TITLE : AIR CONDITIONING - FLOW CONTROL AND INDICATION - INSTALL MODIFIED FLOW  
CONTROL VALVE (FCV) PN 1303A0000-03

MODIFICATION No. : 31575K7453

This page transmits Revision No. 01 of Service Bulletin No. A320-21-1134.

SERVICE BULLETIN No. : A320-21-1134

**B**  
TYPICAL

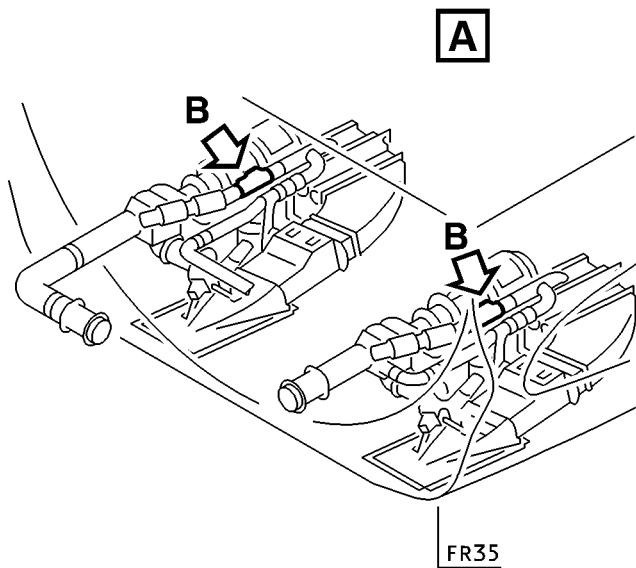
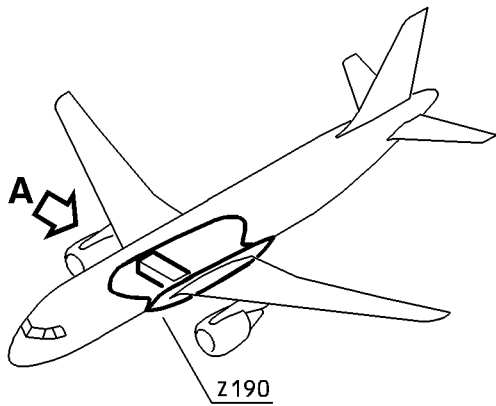
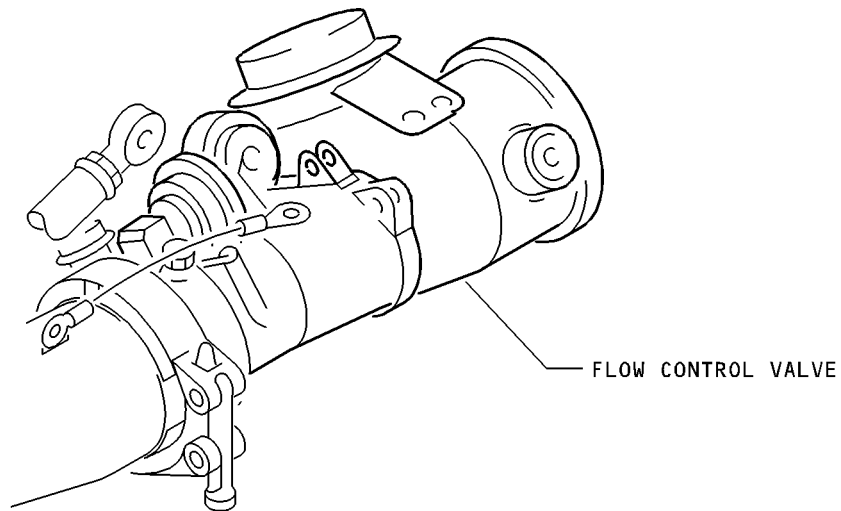
This Service Bulletin advises operators of the issue of LIEBHERR-AEROSPACE Service Bulletin No. 1303-21-03 which details the procedure to replace the existing flow control valves 8HB and 11HB by modified valves. The new, improved valves incorporate numerous modifications including a new overpressure limitation clapper.

Figure 1 Sheet 1  
Removal/Installation of the Flow Control Valves 8HB and 11HB

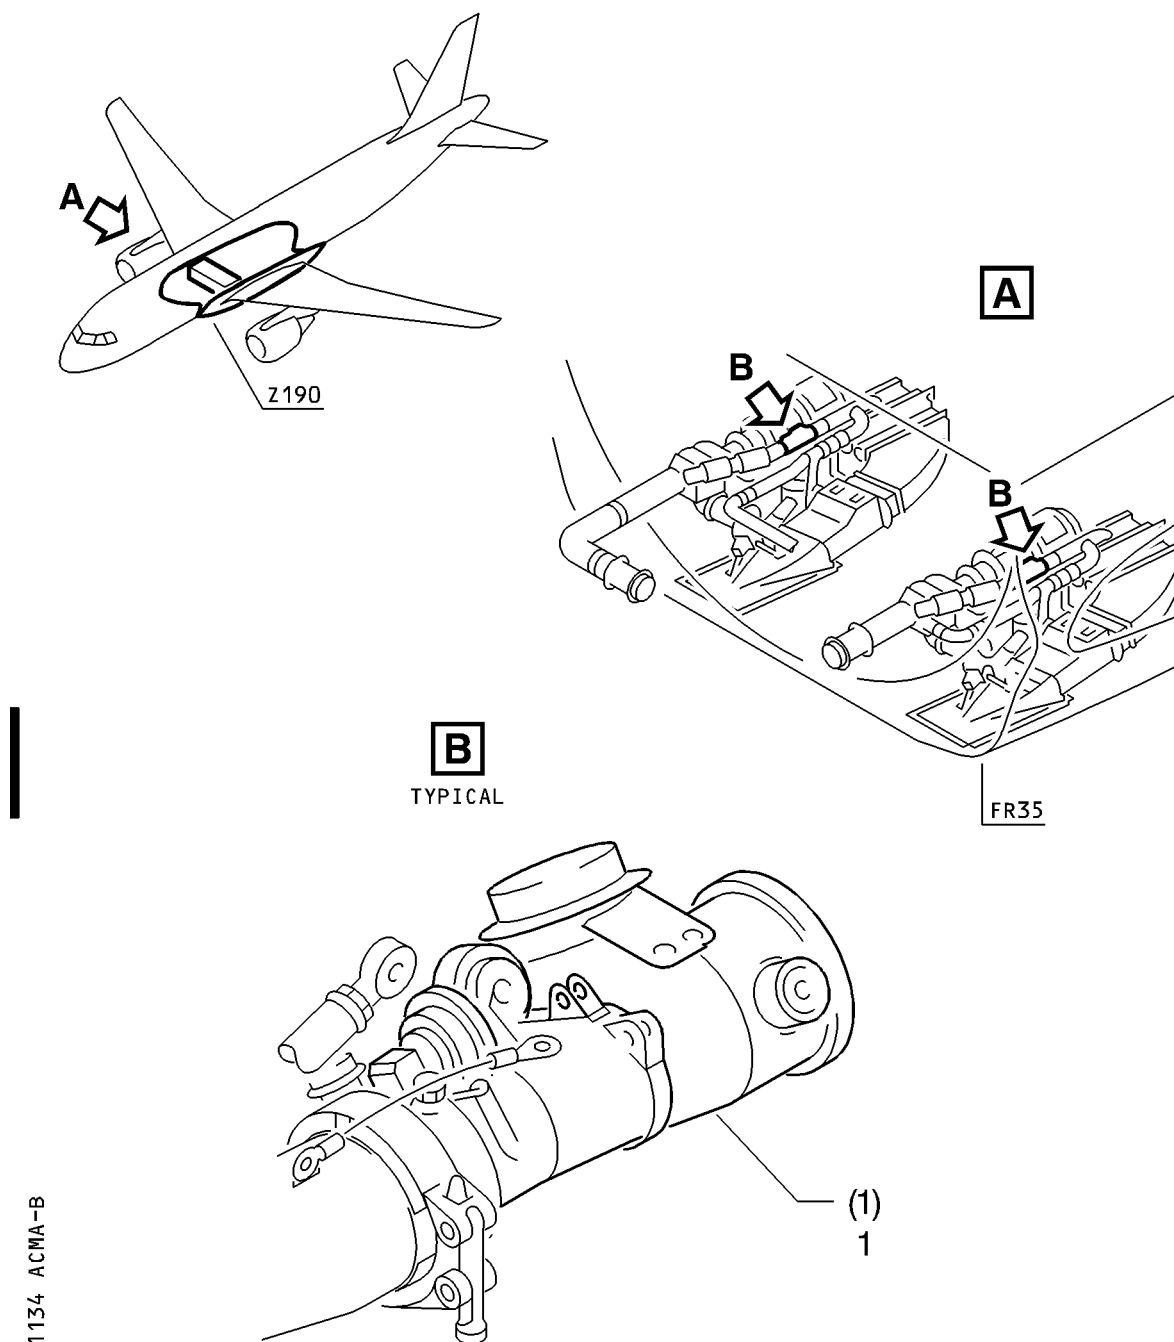
Detail B, TYPICAL added.

Figure 1 Sheet 1, Detail B, TYPICAL added.
